SERVICE BULLETIN

#0014 Revision 1

SUBJECT: Rivet replacement along fuselage main spar carry-through and on upper and lower inboard wing skins

MODELS AFFECTED: All Sling aircraft

Figure 1 - Paint cracking around rivets on Sling 2 wing

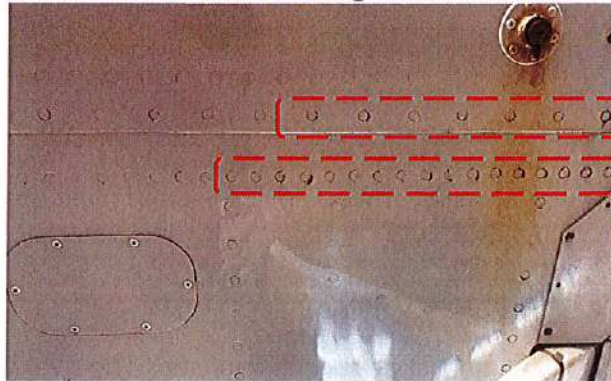
In some Sling aircraft, an indication of this condition is paint cracking around the rivets. The affected regions are usually located on the underside of the fuselage along the main spar carry-through and on upper and lower inboard wing skins. Figure 1 shows paint cracking on the inboard skins of a Sling 2 aircraft.

To minimise fretting, rivets in the affected areas should be replaced with Avinox stainless steel rivets (Part number BE61-00512).

Figure 2 – Region of rivet replacement on the underside of starboard (right) wing

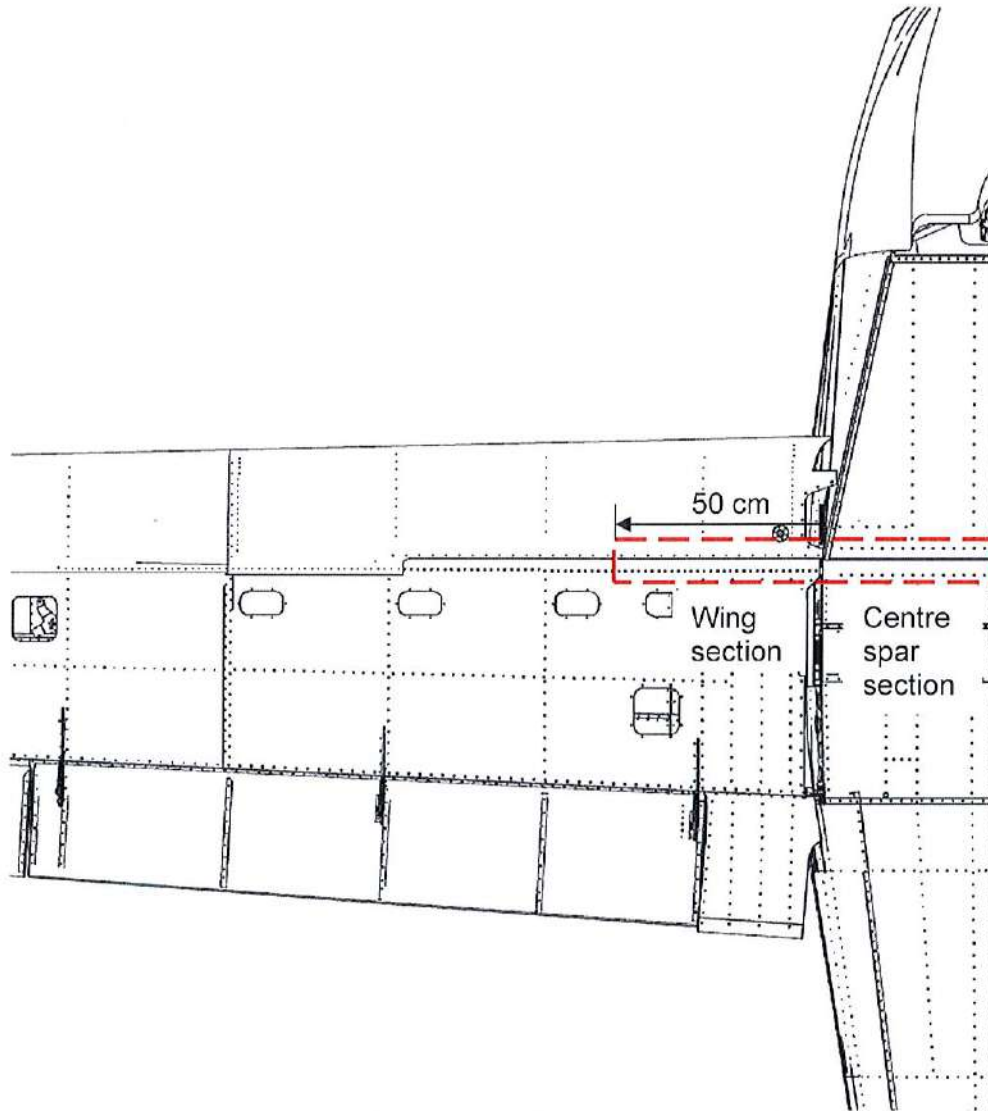
2. On the fuselage (of Sling TSi, Sling 2 and Sling 4 aircraft), this region is along the two rows of rivets that attach the underside centre fuselage skin to the centre spar (see Figure 2).

3. Figure 2 shows one half of the affected region on the underside of the starboard wing and fuselage and Figure 3 shows half the affected region on the upper starboard wing. The quantity of rivets recommended should cover these regions sufficiently.

The Figure 2 and 3 indicate the regions where rivets should be replaced on the aircraft. The rivets for the Sling TSi are replaced only on the centre spar carry-through under the fuselage.

5. Ensure that rivet removal is complete on the top of the wing before starting with the underside.
6. Using the powered drill with the 4 mm drill bit, drill the heads off rivets in the affected regions indicated in Figure 2 and 3 (specifically Figure 4 for Sling 2 and Figure 5 for Sling 4 wings). If rivets are filled, indent the centre of the rivet head with a centre punch and hammer before drilling.

Figure 4 - Number of rivets to replace on Sling 2 and Sling LSA wings

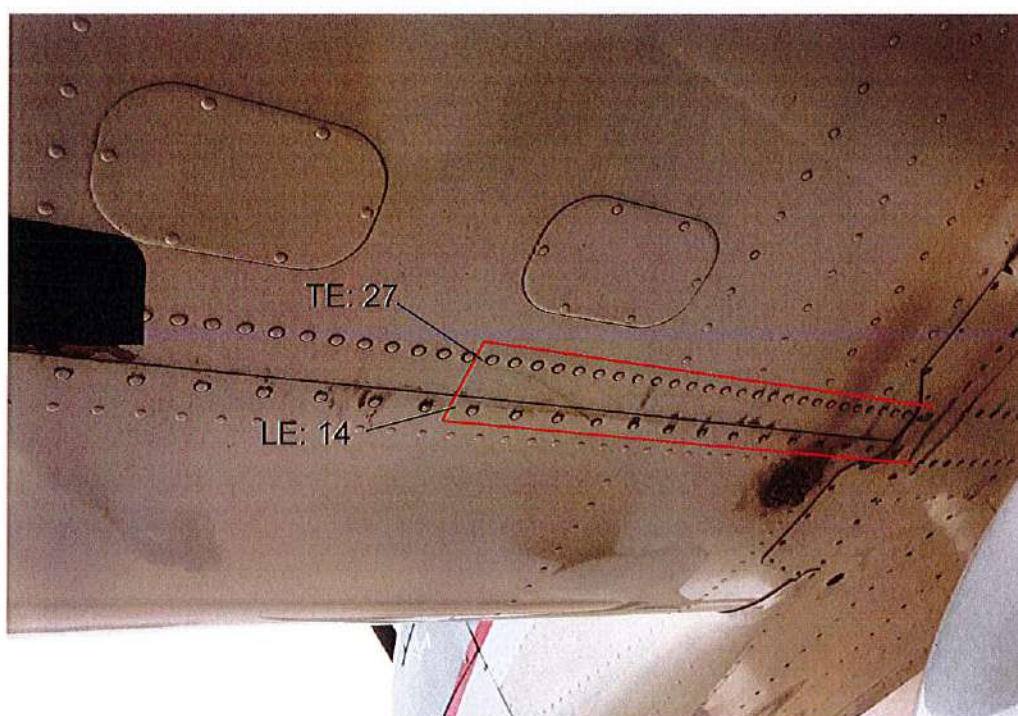
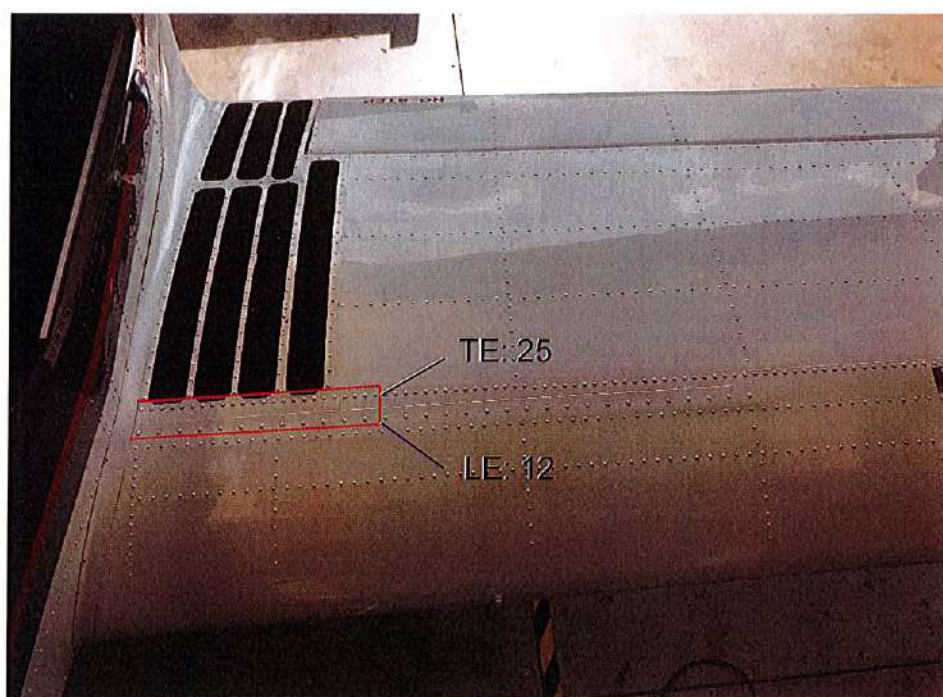
At approximately 50cm (spanwise distance) from the wing root, on the Sling 2 wings, the rivets to be replaced are 12 on the front section (leading edge) and 25 on rear section (trailing edge) of the upper wing spar. On the underside of the Sling 2 wing, the rivets to be replaced are 14 on the leading edge and 27 on the trailing edge as shown in Figure 4.

Hence, the total number of rivets, for both wings = $[(12 + 25) + (14 + 27)] \times 2 \rightarrow 156$ (wings only).

The number of rivets along the centre spar carry-through under the fuselage $\rightarrow 62$ (centre spar only).

In total: $(156 + 62) \rightarrow 218$ rivets (Sling 2)

1. On the top and underside surfaces of both wings (of Sling 2 and Sling 4 aircraft only), the region where rivets should be replaced is along the wing main spar, a spanwise distance of approximately 50cm measured from the wing root (see Figure 4 and Figure 5).

Figure 5 - Number of rivets to replace on Sling 4 wings

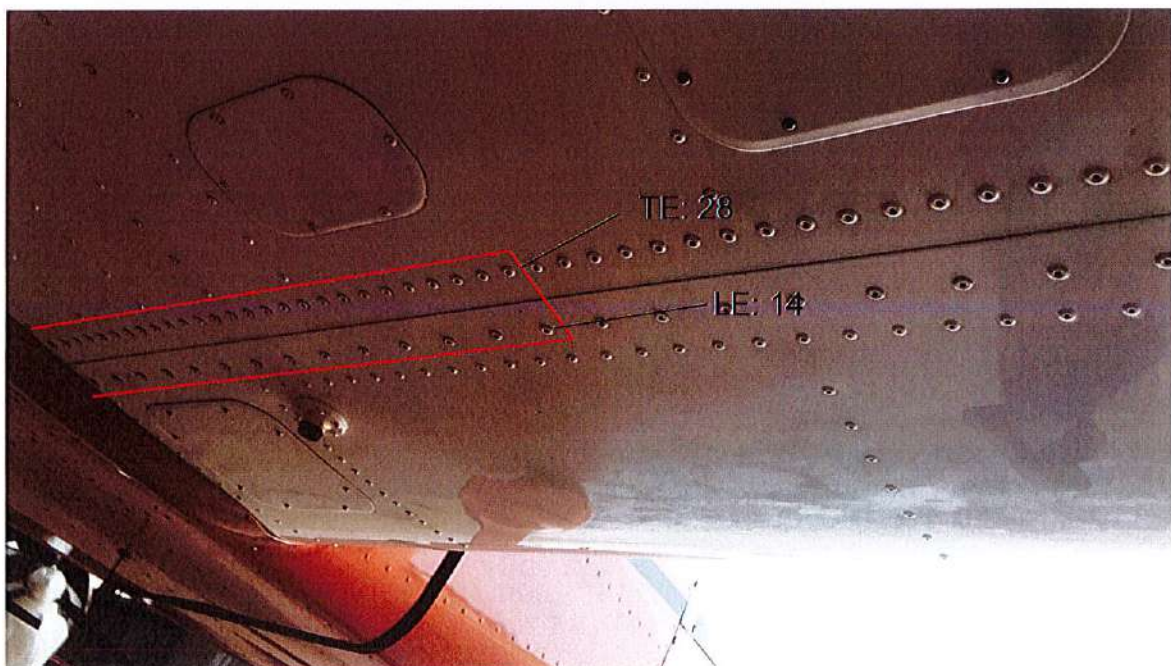
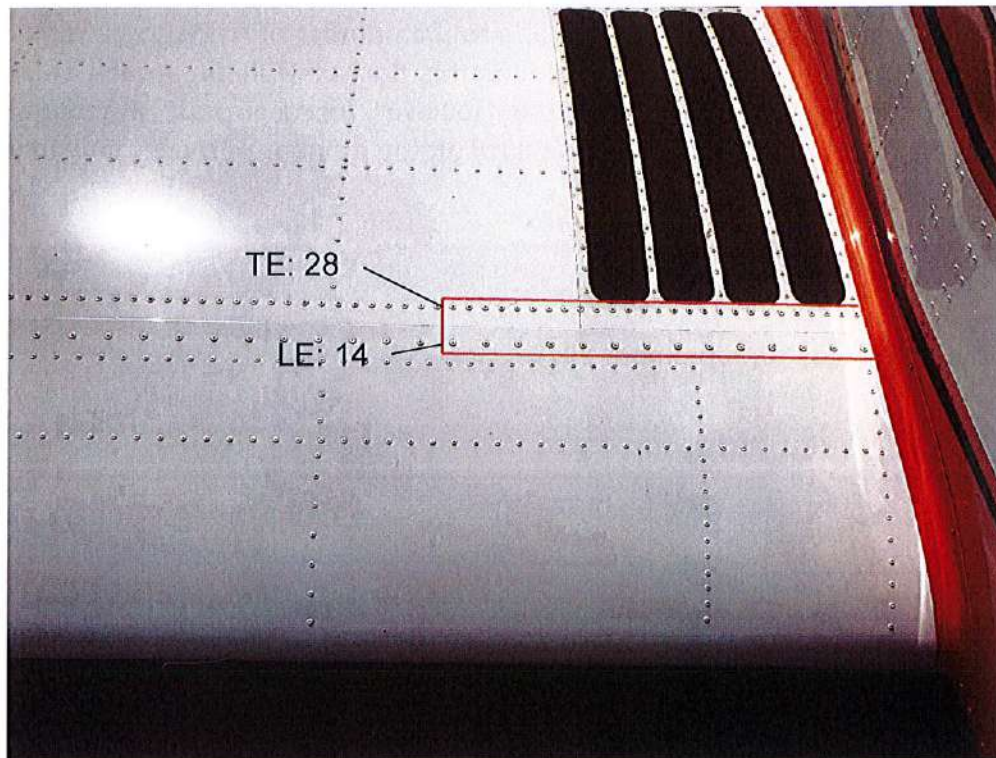
As illustrated below, on the Sling 4 wings, the rivets to be replaced are 14 on the front section (leading edge) and 28 on rear section (trailing edge) of the upper wing spar. On the underside of the Sling 4 wing, the rivets to be replaced are again 14 on the leading edge and 28 on the trailing edge. Hence, the total number of rivets, for both wings = $[(14 + 28) + (14 + 28)] \times 2 \rightarrow 168$ (wings only). The number of rivets along the centre spar carry-through under the fuselage $\rightarrow 62$ (centre spar only). In total: $(168 + 62) \rightarrow 230$ rivets (Sling 4)
